From: Andrew Tull <andrew.tull@3j-consulting.com>
Sent: Tuesday, April 03, 2018 5:11 PM
To: Brett Kelter
Cc: Dennis Egner; Liden; Alex Roller
Subject: RE: completeness letter for Lake Rd fields project (CSU-2018-001)
Attachments: 2-0.pdf; 5-5.pdf

Subject: completeness letter for Lake Rd fields project (CSU-2018-001)

OVERALL SITE PLAN
MILWAUKIE HS LAKE RD FIELD IMPROVEMENTS
MILWAUKIE, OREGON

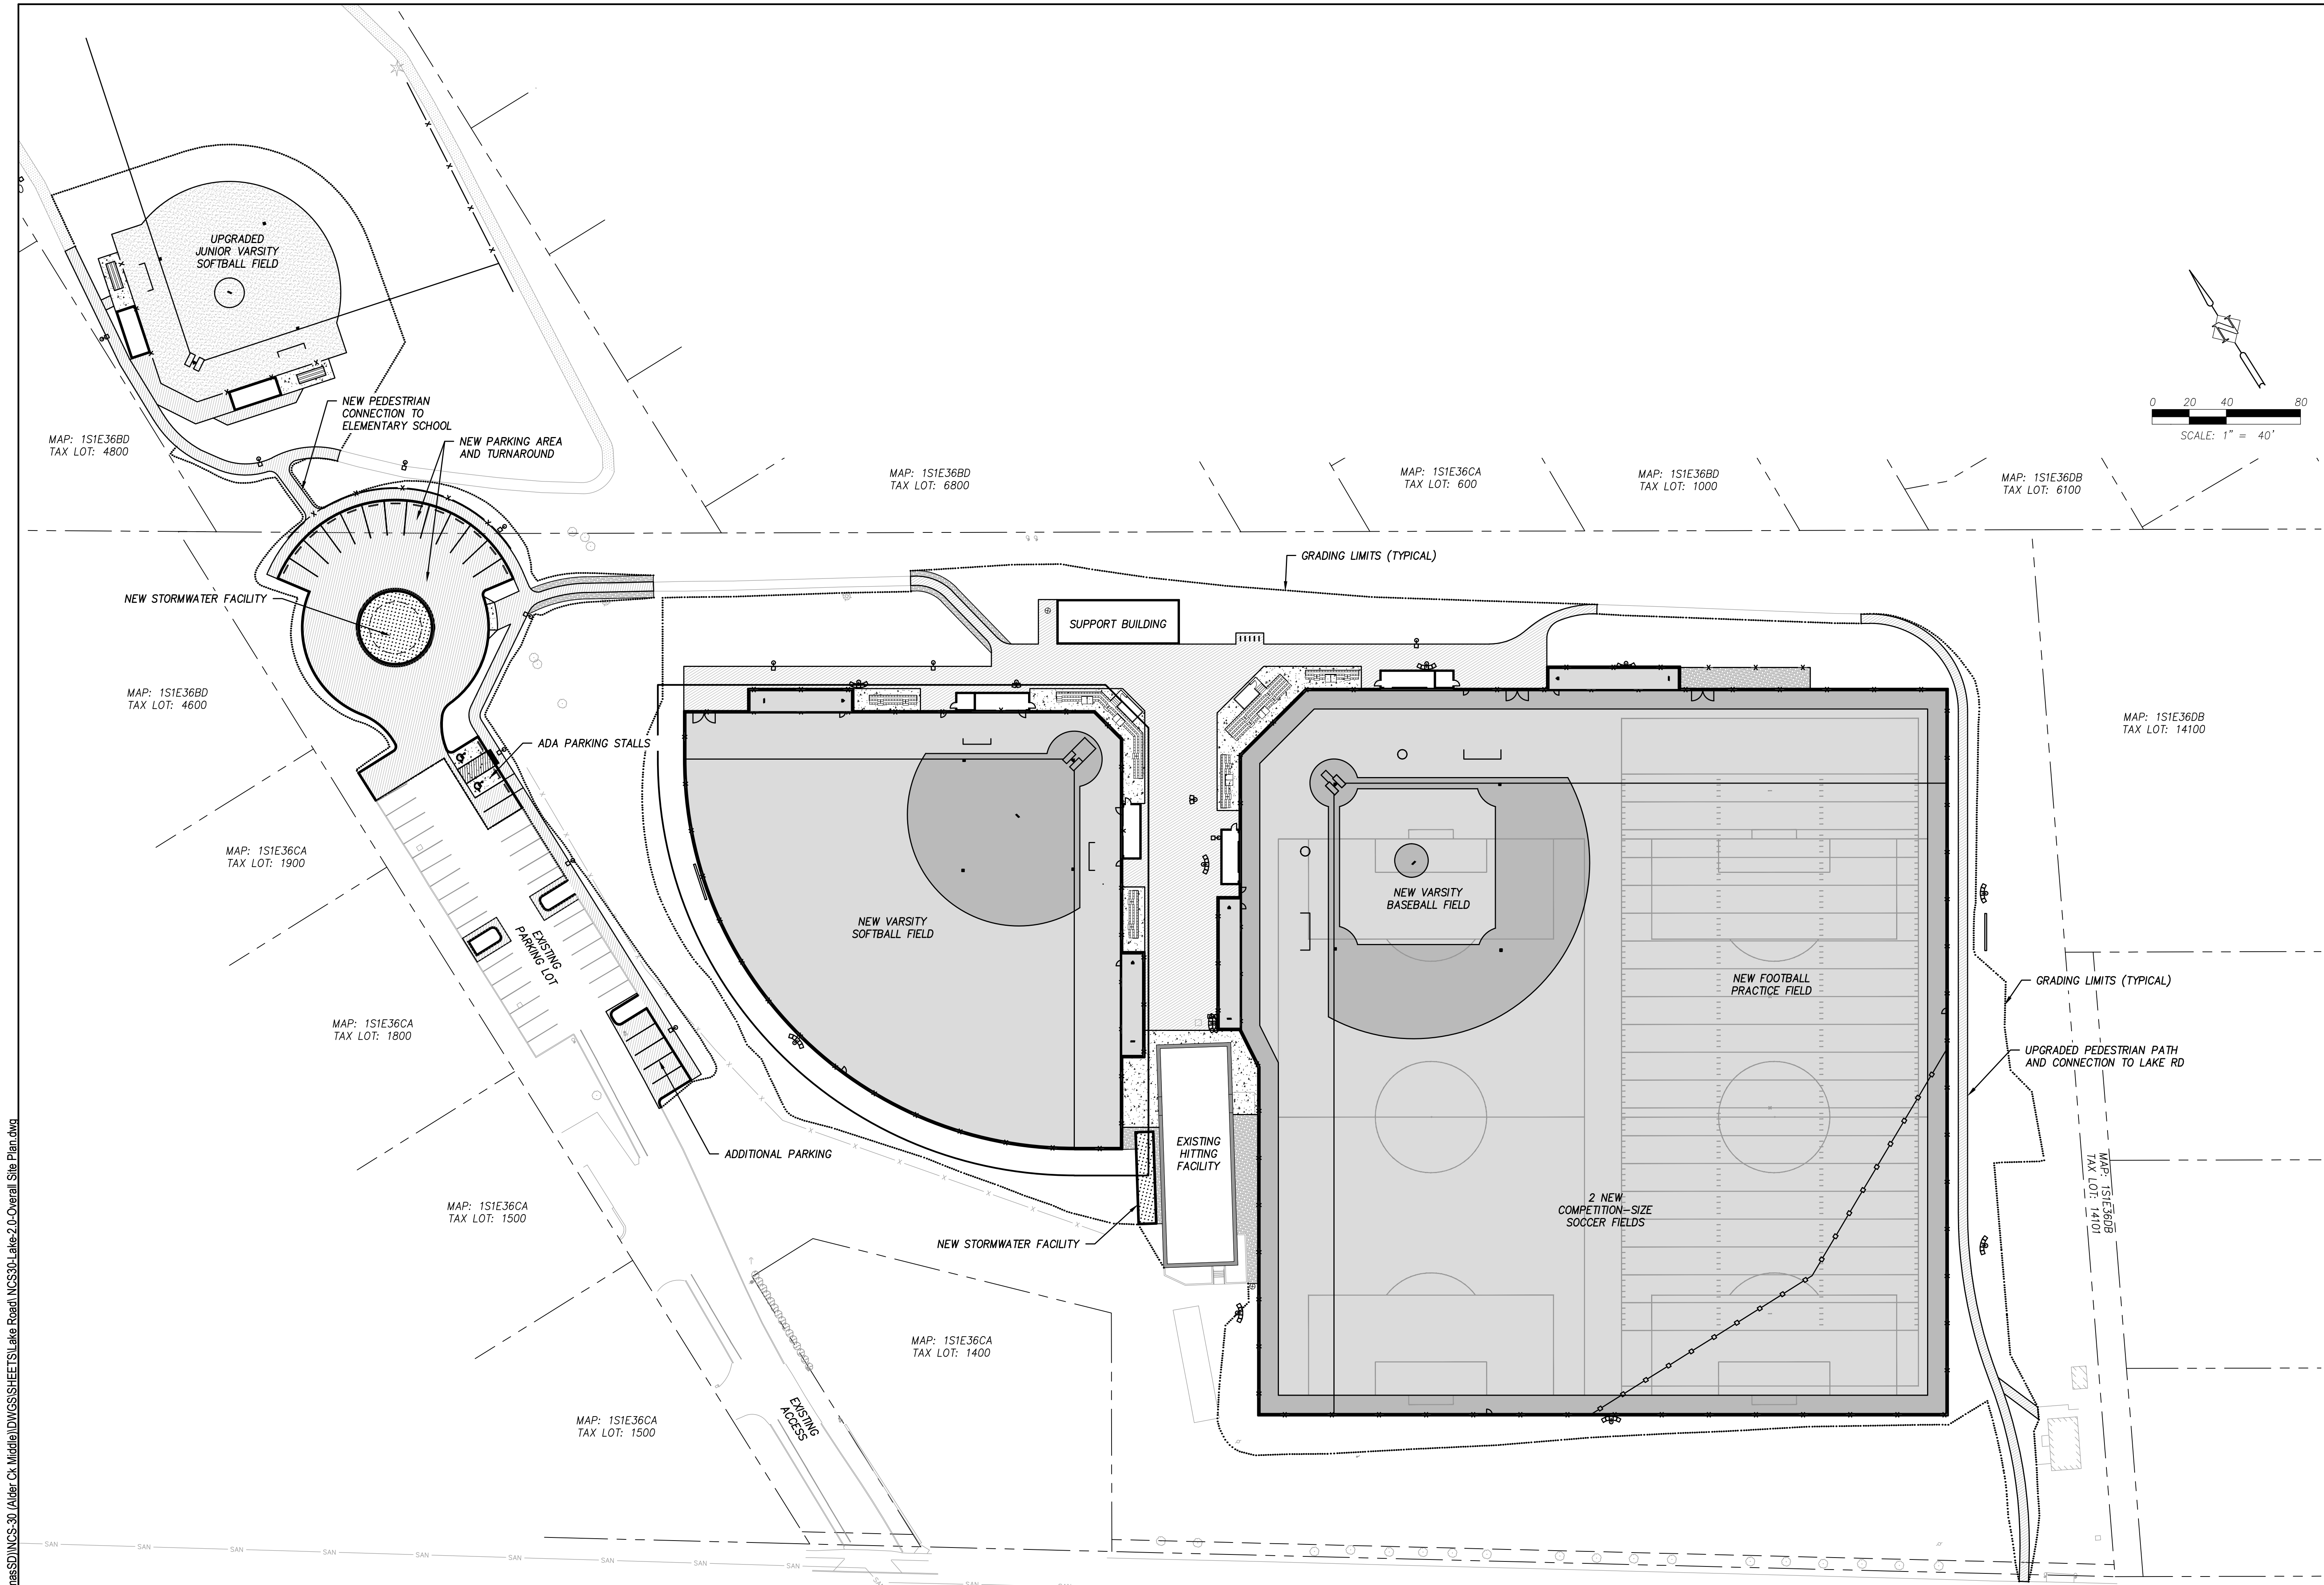
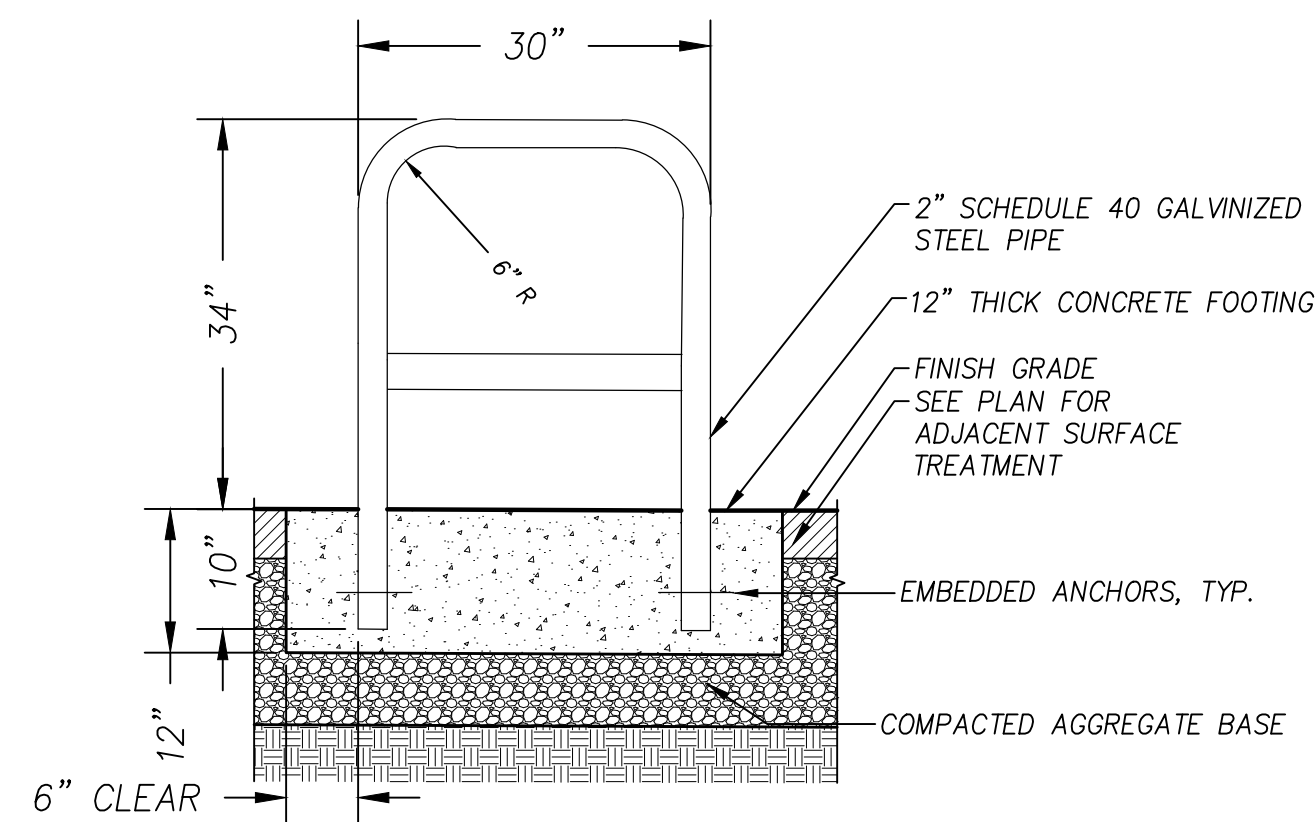
Landscaping – Note that on Sheet L1.0 it is difficult to distinguish between the areas where artificial turf is proposed and where natural grass will remain. This relates to the calculation of minimum vegetation for the site.

The attached plan should help clarify – Plan 2-0.
